UNITED STATES PATENT AND TRADEMARK OFFICE

APPLICATION NO.	FILING DATE	FIRST NAMED INVENTOR	ATTORNEY DOCKET NO.	CONFIRMATION NO.
10/661,477	09/15/2003	Ryuji Sugita	Q77477	9243
23373	7590	05/17/2004	EXAMINER	
SUGHRUE MION, PLLC 2100 PENNSYLVANIA AVENUE, N.W. SUITE 800 WASHINGTON, DC 20037			UHLIR, NIKOLAS J	
			ART UNIT	PAPER NUMBER
			1773

Office Action Summary

DETAILED ACTION

Figure 1

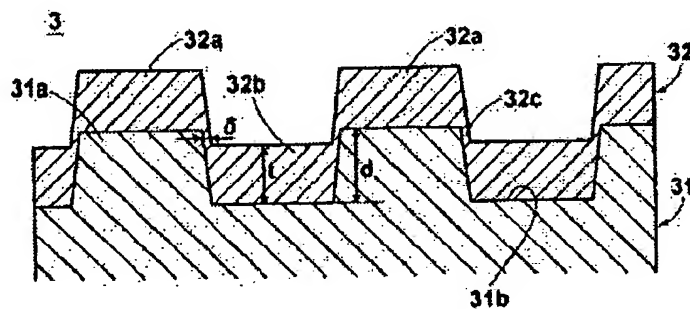
3. Claims 8-9 are rejected under 35 U.S.C. 112, second paragraph, as being indefinite for failing to particularly point out and distinctly claim the subject matter which applicant regards as the invention. Specifically, it is unclear what dimension the thickness of the sidewall (δ) is when the thickness of the magnetic layer (t) is greater than or equal to the depth of the recessed portions (d). As is clearly shown by figure 1, when t is less than the depth of the recessed portion, δ is the width of the portion of the magnetic layer that connects the magnetic material in the recessed portion to the magnetic material on the protrusions.

However, when t is greater than or equal to d (as is allowed by claim 1), how δ is measured is unclear. When $t \geq d$, is δ the thickness of the portion of the magnetic layer where the magnetic material on the protrusion portions and the magnetic material on the depression portions overlap, or can it be the entire width of the magnetic material filling the depression portion? Clarification is required.

4. For the purpose of this examination, the examiner interprets δ , when $t \geq d$ to be the thickness of the portion of the magnetic layer where the magnetic material on the protrusion portions and the magnetic material on the depression portions overlap.
